RE: Comments on the Revised Baseline Modeling Report

COMMENTS OF THE GENERAL ELECTRIC COMPANY ON

Phase 2 Report - Review Copy
Further Site Characterization and Analysis
Volume 2D - Revised Baseline Modeling Report
Hudson River PCBs Reassessment RI/FS
January 2000

November 2000

Figure 14. Fort Edward solids rating curves using three different data sets.

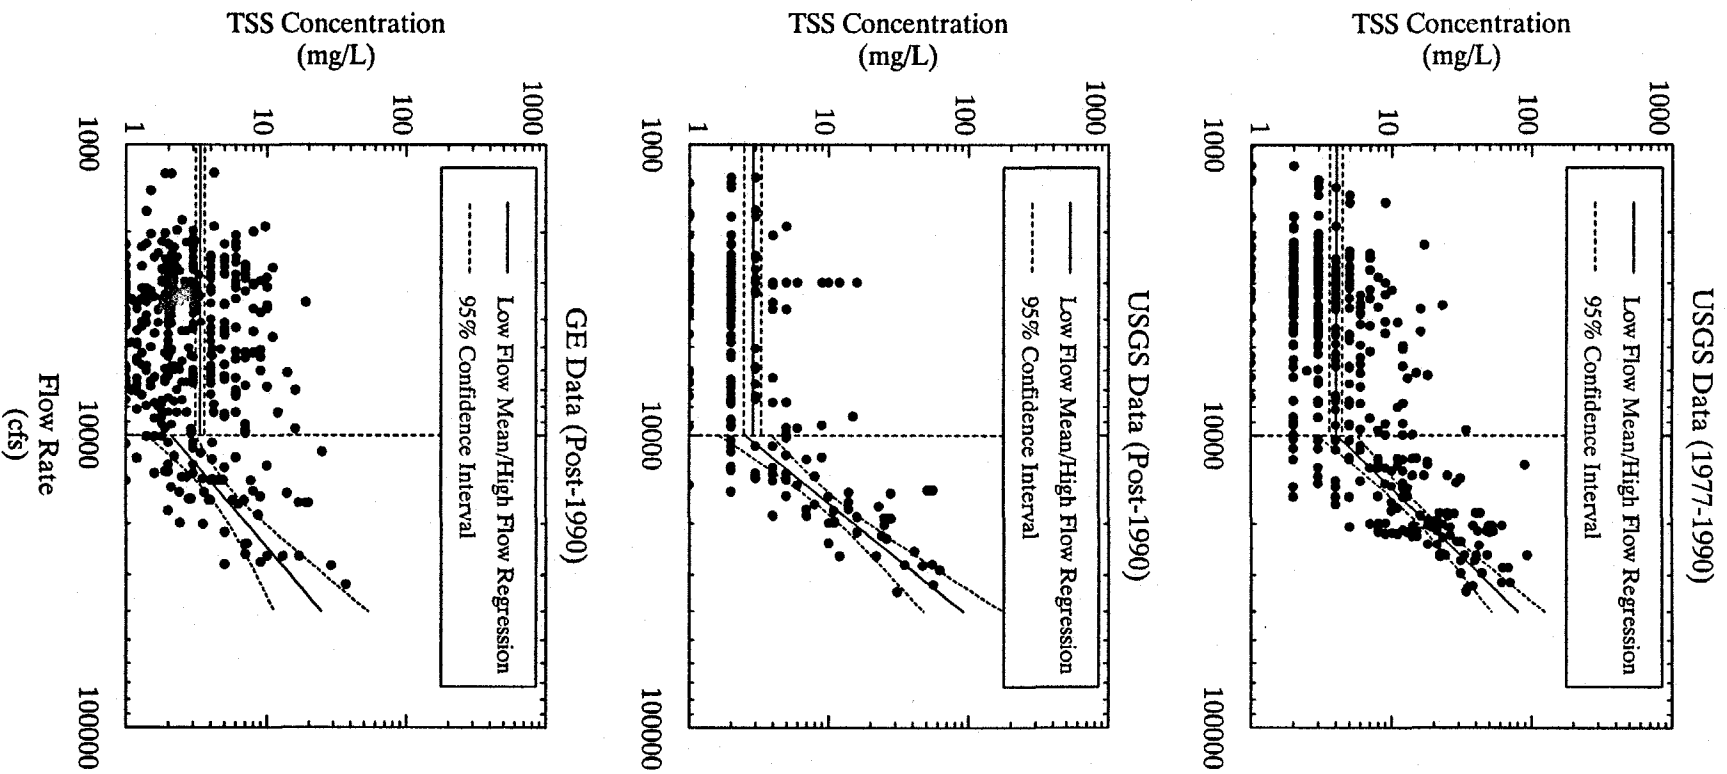
It appears that USEPA's hypothesized reduction in solids loading after 1990 is due to the Agency's reliance on the GE data, as illustrated by comparing the USGS post-1990 rating curve with the GE post-1990 rating curve. Comparing the two data sets in this manner is crucial because: 1) all of the data are used, not just a limited number of paired measurements and 2) differences in solids loading estimates can be quantified. Large differences between the resulting

rating curves, particularly in the high-flow regime, are evident in Figure 14. These rating curves were used to calculate Fort Edward solids loading for an eight-year period, from January 1, 1991 to December 31, 1998 (Figure 13). The rating curve developed from the GE data produced a total solids load for this period that was 24% lower than the USGS rating curve overall, with a much larger difference during high-flow periods (54% lower) than during low-flow periods (17% higher). The apparent low-bias of the GE TSS concentration data during high-flow conditions probably results from the configuration of the sampling device and the sampling procedure, as described previously (Figure 12). Thus, the GE TSS concentration data should not be used for calculating total suspended solids loading at Fort Edward.

Figure 15. USEPA (specified) and GE (calculated) relationships between effective settling speed and flow rate for the cohesive bed in the TIP.

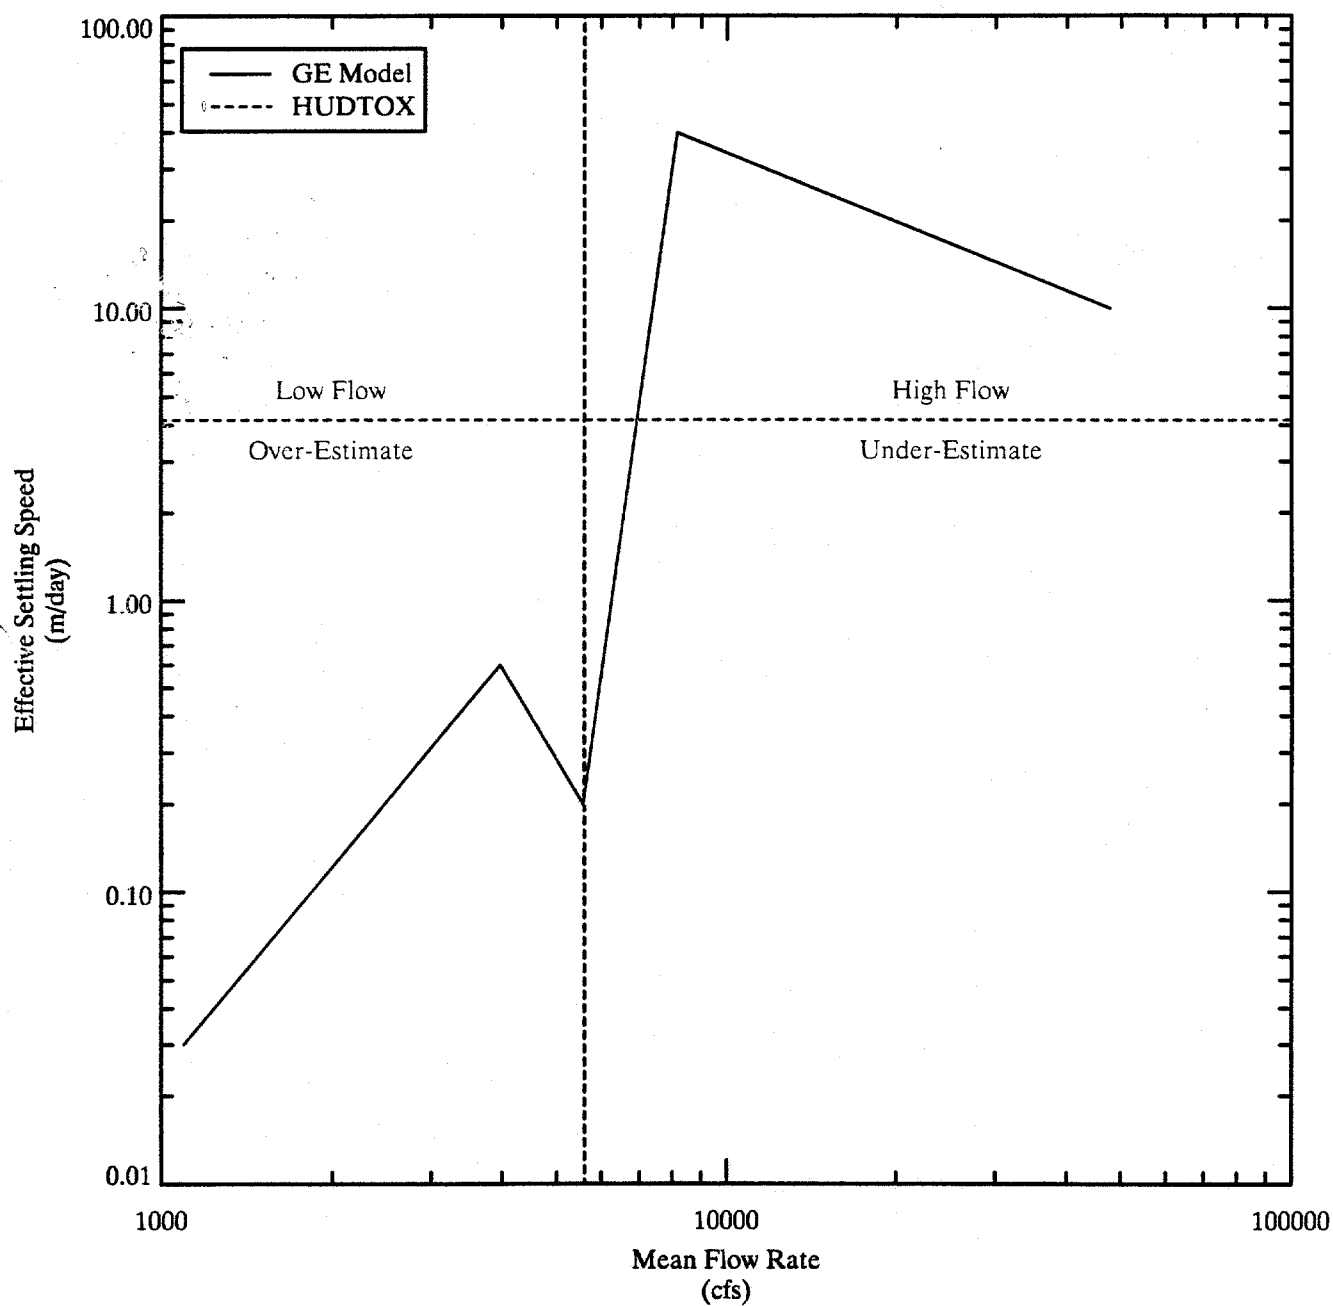
Similar deposition formulations were applied to cohesive and non-cohesive bed areas in HUDTOX. Effective settling speeds used in HUDTOX were temporally constant and spatially variable, with a higher value in cohesive areas than in non-cohesive areas. This approach overlooked three important phenomena that affect deposition: 1) variable bottom shear stress or, equivalently, flow rate (i.e., probability of deposition effects); 2) changes in composition of water column solids (i.e., relative amounts of clay, silt and sand in suspension); and 3) flocculation of clay and silt particles. An example of these effects on effective settling speed is illustrated in Figure 15, which shows results from the GE sediment transport model for a cohesive bed area in the TIP (QEA 1999). The effective settling speed relationship shown on Figure 15 is typical for the Upper Hudson River, with relatively low settling speeds during low-flow conditions due to most of the suspended load being composed of flocculating clay and silt particles. During high-flows, there are significant increases in suspended sand content causing the effective settling speed to increase by more than an order of magnitude. Even though the HUDTOX effective settling speed for cohesive bed areas (4.15 m/day) may approximate a long-term average value, it is too high during low-flow and too low during high-flow (Figure 15).

Figure 16. Total discharge and sediment loads input to tributaries in Schuylerville - Stillwater reach.

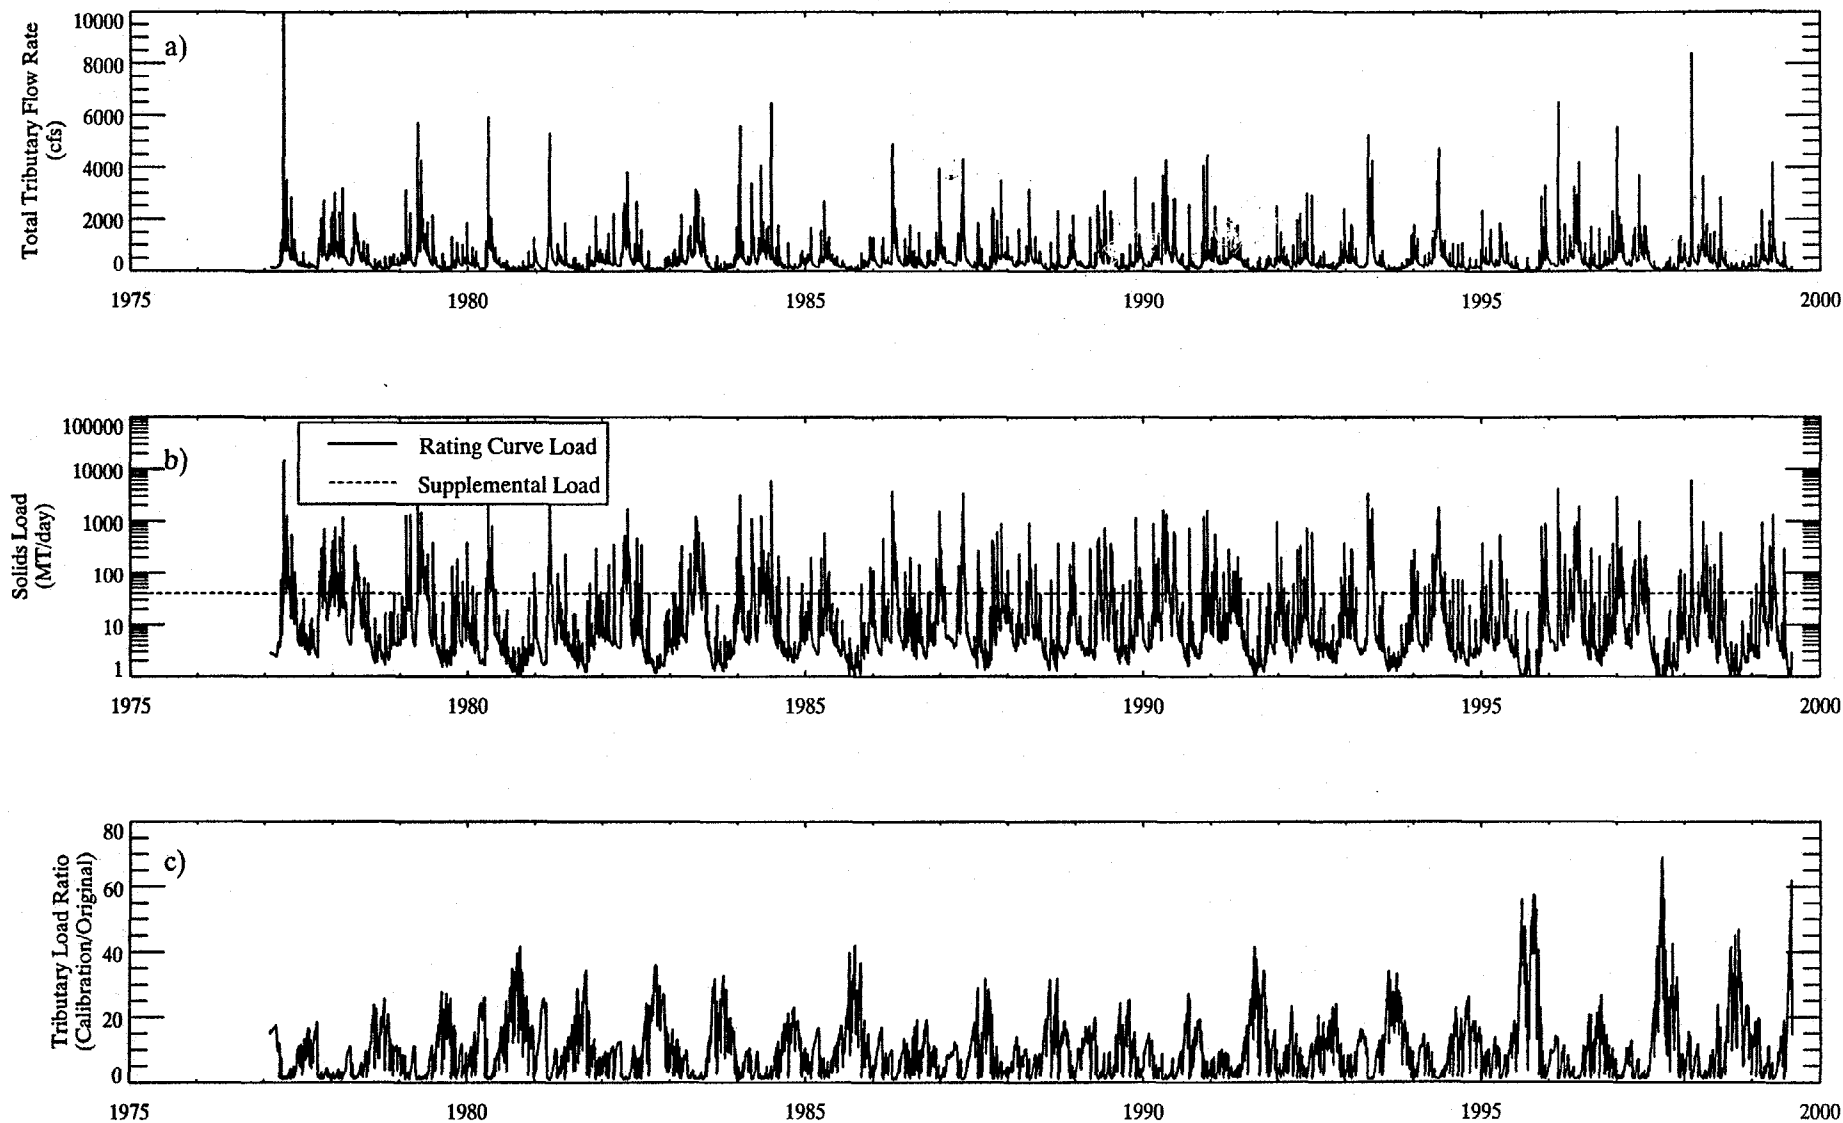
To calibrate its model, USEPA adjusted solids loadings from the tributaries downstream of the TIP (USEPA 2000), especially during low-flow conditions. Unfortunately, the RBMR does not provide sufficient information to determine the cause and extent of the initial calibration difficulties. Thus, USEPA input an additional tributary solids load of 40 metric tons/day (MT/day) to both the Schuylerville-Stillwater and Stillwater-Waterford reaches during the final calibration. Although USEPA portrays this load increase as being within the uncertainty range of the estimated tributary loads (USEPA 2000), a closer examination reveals that the magnitude of the supplemental solids loading was not trivial during low-flow periods, i.e., below mean tributary flow rate. While the increase in long-term solids loading was about 26 and 17% for the two reaches, respectively (USEPA 2000), the relative increase in tributary solids loading was much greater during low-flow conditions. Figure 16b shows a temporal comparison of the tributary loading for the Schuylerville-Stillwater reach specified by: 1) time-variable rating curves (developed from the solids load analysis referenced above and used during initial model calibration) and 2) constant load of 40 MT/day. During low-flow conditions, the supplemental load is significantly greater than the original rating curve load. The magnitude of this disparity in the Schuylerville-Stillwater reach is illustrated in Figure 16c, which shows the temporal variation of the ratio of the final calibration rating curve loading (initial rating curve load plus supplemental load) to the initial rating curve loading. This ratio increases as the flow decreases, with maximum values of about 70X and 12X for the Schuylerville-Stillwater and Stillwater-Waterford reaches, respectively. The ratio is greater than two 83% of the time between 1977 and 1999 for the Schuylerville-Stillwater reach. Assuming that uncertainty about the rating-curve-estimated loading is about a factor of two, then this percentage represents the portion of time during which the assumption of a constant supplemental solids loading of 40 MT/day is **not** within the assumed uncertainty range of the tributary solids loading.

Figure 18. Comparison of fish growth rates, fish lipid content and sediment organic carbon contents used in FISHRAND with measured values.

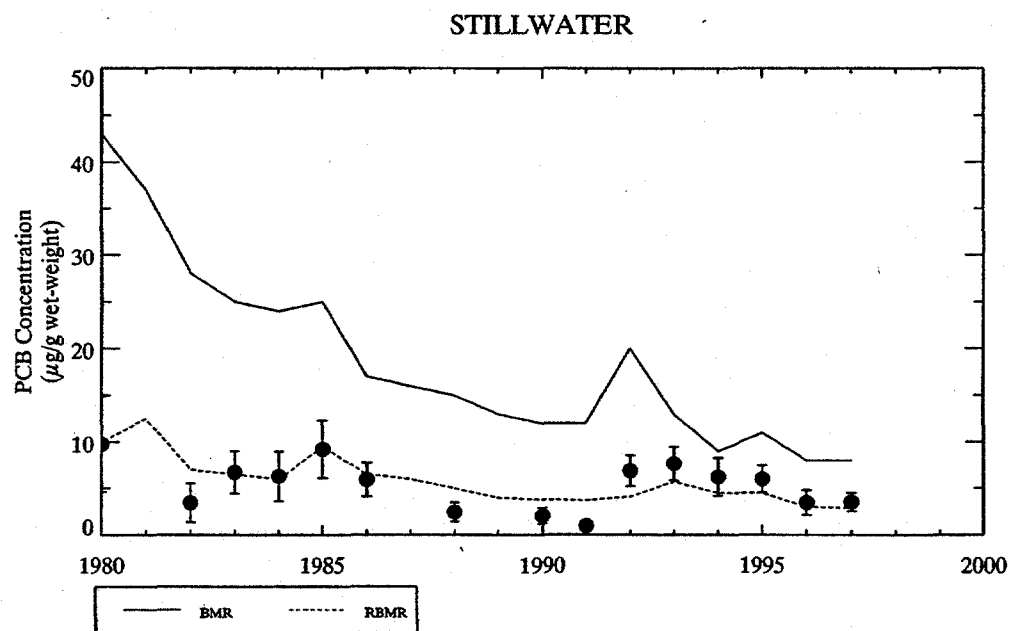
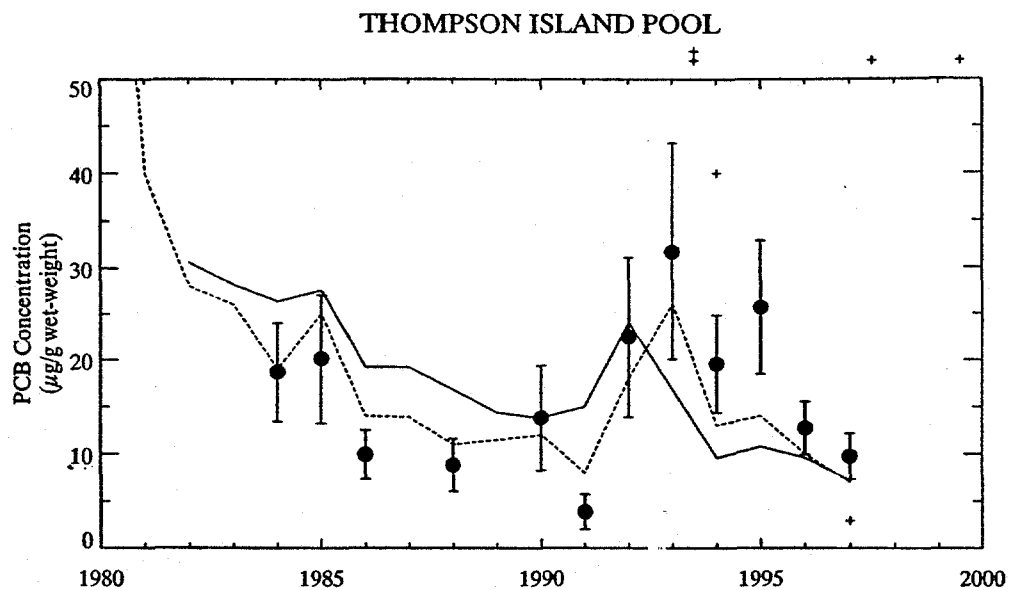
There are three problems with USEPA's estimation of fish lipid contents. First, calibration resulted in lipid contents different from the best estimates based upon the data collected by NYSDEC during their PCB monitoring program. For example, the fraction lipid in the largemouth bass used at Stillwater (geometric mean = 0.006 g lipid/g wet weight) is less than ½ of the mode of the data (0.014). In contrast, a value more similar to the data (0.011) is used in Thompson Island Pool. Lipid contents for the other modeled species are also modified independently of the data and independently for each reach, for example spottail shiner (Figure 18).
